HYUNDAI Technical Service Bulletin	GROUP CAMPAIGN	NUMBER 17-01-069
	DATE DECEMBER, 2017	MODEL(S) SONATA 2.4L (LFa)
SUBJECT: A/C BRACKET BOLT INSTALLATION (SERVICE CAMPAIGN T2O)

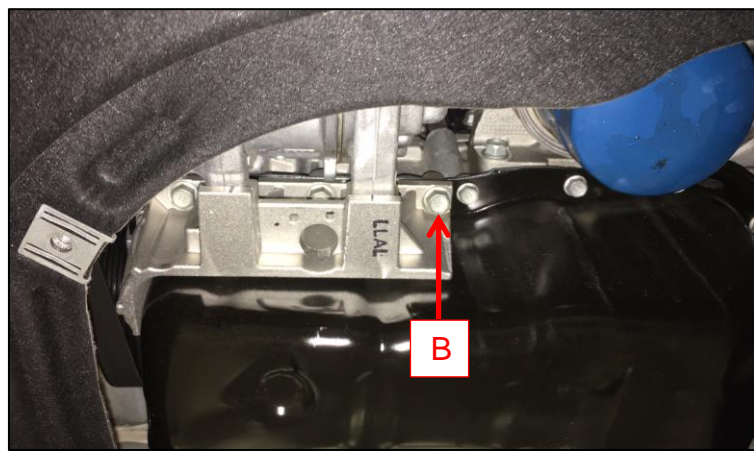
1. Lift the vehicle on a hoist and remove the seven underbody access cover bolts (A) to remove the access cover.
 - **Tightening torque: 10 Nm (88.5 lb-in)**

2. Install the missing A/C bracket bolt (B). (If bolt already exists, then retighten.)
 - **Tightening torque: 23 Nm (17 lb-ft)**

3. Verify that the A/C compressor bracket is now properly attached to the engine block and then reinstall the underbody access cover.
